**Re: Bridge No. 2440 Rehabilitation Dive Inspection Summary for 2014**

AMI Project # 141122

Minnesota Department of Transportation  
 Bridge No# 2440  
 Dive Inspection  
 Saint Paul, Minnesota  
 General Plan & Section Details

**2**  
S1.0  
PIER 1 SECTION  
SCALE: 1" = 20'-0"

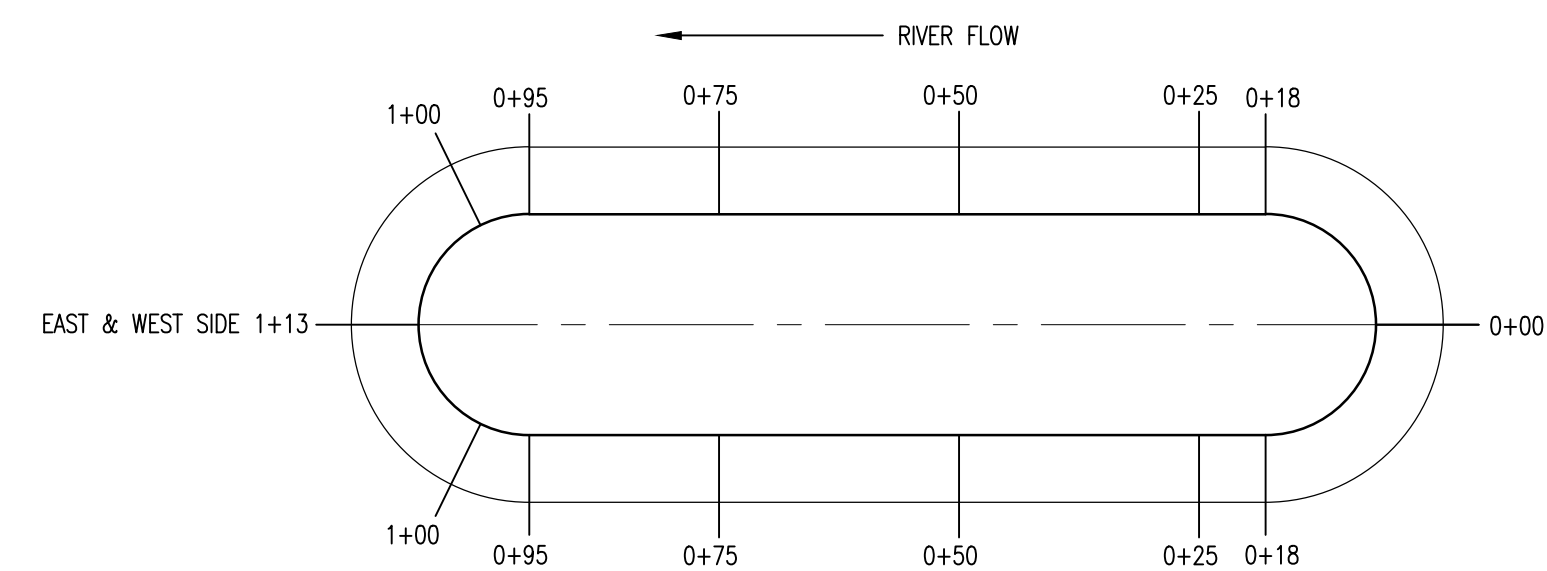
For the deteriorated concrete near the waterline, the construction documents required a horizontal saw cut at the base of the rehabilitation area that penetrated the concrete pier 3" to 5". The face of the concrete at the saw cut location was heavily deteriorated with areas of spalling concrete. Due to the spalling concrete and the resulting uneven surfaces, the saw cut did not penetrate the concrete pier the specified minimum of 3" on approximately 15% on the concrete pier. As a result of the smaller saw cut, the distance from the vertical dowel to the inside face of the concrete forms was also less than the specified minimum distance of 3".

The distance between the vertical rebar also exceeded the specified spacing of 12". The ACI code allows a placement tolerance of ¼ times the specified spacing but not to exceed 1". This results in a maximum allowable spacing of 13". Approximately 50% of the vertical rebar were spaced greater than 12" and 25% to 30% of the vertical rebar were spaced greater than 13". The maximum spacing between the vertical rebar was 14".

After each concrete pour, AMI re-inspected the new concrete to document any areas of washout or deficiencies. On the east and west side of the pier, the new concrete had migrated below the saw cut. The forms were slightly out from the original vertical concrete face of the pier which allowed the concrete to migrate below the saw cut due to the spalling concrete. The location of the forms did allow for additional concrete cover on the rebar. The concrete below the saw cut had areas of honeycombing that were about 5" to 6" in height. On the west side of the pier, a large area of concrete was missing presumably due to a failure of the concrete forms. The area of missing concrete was approximately 18.5" tall with a maximum penetration 4" which exposed one vertical bar and one vertical dowel of the new rebar. To remedy this area, the contractor installed a 3'-0" tall by 4'-0" wide concrete form that protruded from the new concrete face 1-<sup>7</sup>/<sub>8</sub>". The missing area of concrete was located approximately at station 0+35 on the west side of the pier. AMI was unable to re-inspect this repair after the concrete had been placed due to early freeze up.

In one area where the new concrete had not migrated below the saw cut, the bottom edge of the new concrete protruded out from the existing concrete face. The maximum protrusion or lip was approximately <sup>3</sup>/<sub>4</sub>" over an 8'-0" long horizontal area and was located near the upstream tip of the pier. Because of this lip, the bottom edge of the new concrete is susceptible to damage from ice impacts and abrasion.

**3**  
S1.0  
PIER 2 SECTION  
SCALE: 1" = 20'-0"

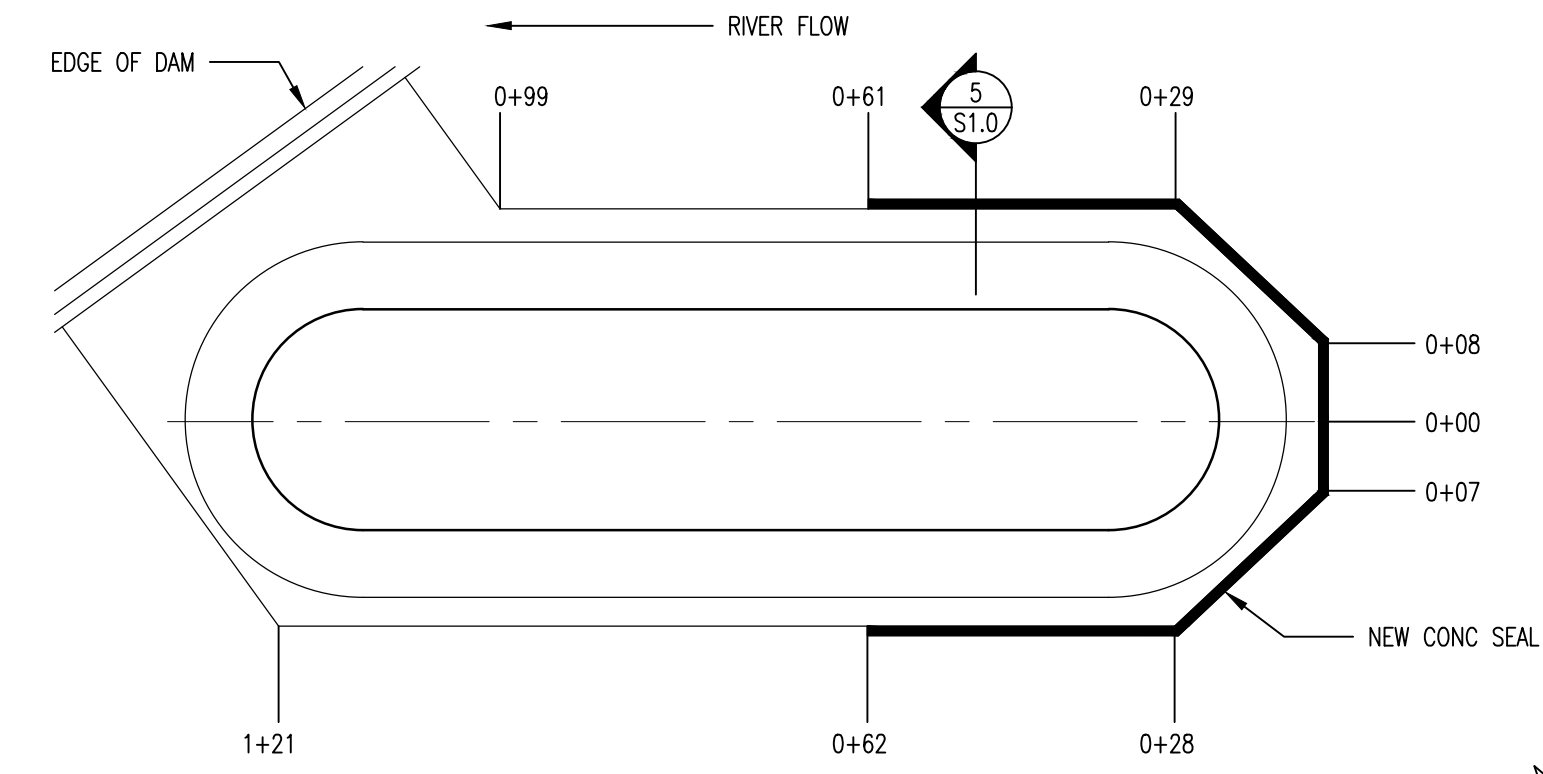
The condition of the horizontal saw cut and spacing of the vertical rebar were very similar to the conditions described for pier #1. However, the spacing of the bottom horizontal rebar was also outside the specified spacing of 12". The bottom horizontal rebar was not set at a consistent elevation and had a wave profile to it. This caused a maximum distance to the adjacent bar to range greatly with a maximum distance of 13 3/8".

The condition of the new concrete on the upstream half also had areas of honeycombing concrete below the saw cut which were similar to pier #1. No areas of missing concrete were documented but the concrete forms were still present on the downstream half of the pier during AMI's last inspection. Two vertical bulges in the new concrete were documented near the upstream tip of the pier. The bulges have occurred at the location where two concrete forms butt up to each other. The bulge appears to be ground smooth above the waterline but a very apparent edge was still present below the waterline. The maximum difference between the two concrete faces was approximately 2" over a distance of 2'-0".

**4**  
S1.0  
PIER 5 SECTION  
SCALE: 1" = 20'-0"

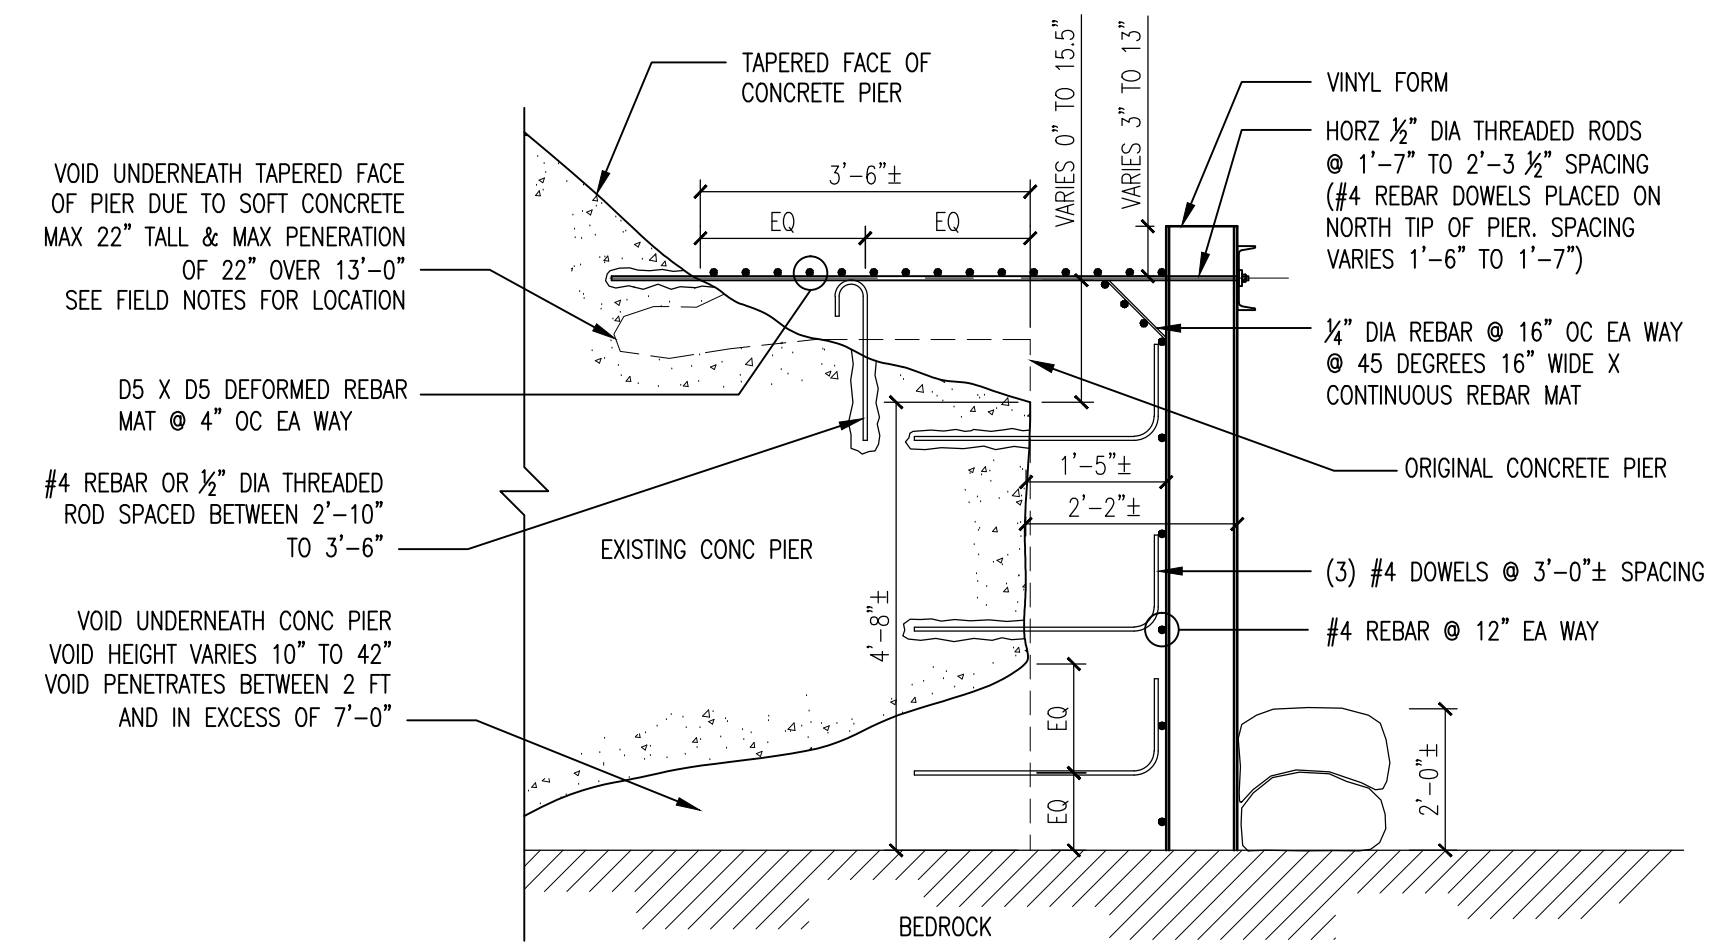
To rehabilitate the scour hole below the pier, the contractor had to remove any loose sediment and debris from below the pier and then place 6'-0" to 7'-0" tall forms around the scour areas. The new concrete would extend up from the bedrock to the horizontal face of the concrete pier. During the process of removing loose sediment and debris below the pier, the contractor discovered very low strength concrete or grout located along the vertical face of the existing concrete footing. The thickness of the low strength concrete or grout varied from 6" to the entire height of the vertical face of the pier footing. The low strength concrete or grout also appeared to extend underneath the tapered face of the concrete pier. Due to the large volume of the low strength concrete or grout, the areas were not removed but encased in additional concrete that extended above the horizontal face of the pier. A general cut section of the new repairs can be seen in detail 5/S1.0 of the attached AMI drawings.

The new repairs consisted of an additional D5xD5 deformed rebar mat with 4" spacing above the horizontal face of the existing concrete pier. The mat was attached to the existing concrete pier with horizontal and vertical dowels. The vertical dowels were a mixture of #4 rebar and 1/2" diameter threaded rod while the horizontal dowels were primarily 1/2" diameter threaded rods. However, some #4 horizontal rebar dowels were documented near the upstream tip of the concrete pier. MnDot onsite personnel verbally approved the change from rebar to threaded rods.

The new concrete forms extended from the upstream tip of the pier to station 0+62 on the east side and to station 0+60 on the west side of the pier. However, the void below the footing extended further downstream of the concrete forms. Additional grout bags were placed along the void prior to concrete being placed below the pier. The grout bags extended to station 0+72 on the east side and to station 1+03 on the west side of the pier.

The construction documents call out an area of deteriorated concrete on the east side of the pier. The area was approximately 5'-0" wide by 3'-0" tall with a penetration that ranged from 2'-0" to 3'-0". This area was located on the construction documents at 3'-0" below the normal river elevation on the tapered face of the concrete pier. However, a spall of that size was not documented by the contractor or AMI. An area of honeycombed concrete with a similar area was documented near the specified area but the penetration was only 2" instead of 2'-0" to 3'-0". This area will need to be addressed during the 2015 construction.
